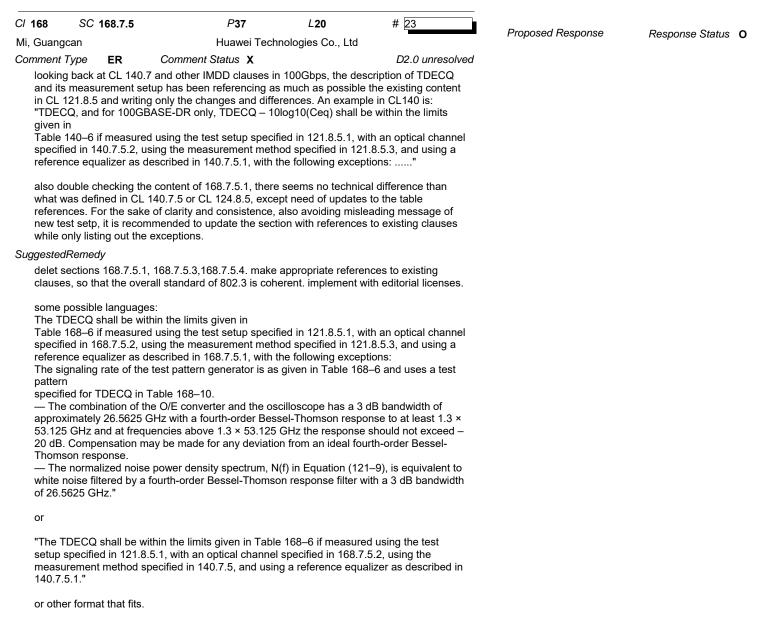
C/ 168	SC 168.7.4	P 36	L 41	# 22
Mi, Guang	jcan	Huawei Tech	nologies Co., Ltd	
Comment	Type TR	Comment Status X		D2.0 unresolved
	t clauses has bee 3 as well.	n pointing out the source of (OMAout data. Re	commend to add in

add "OMAouter is measured using waveforms captured at the output of the reference receiver defined in 168.7.5, before the reference equalizer.
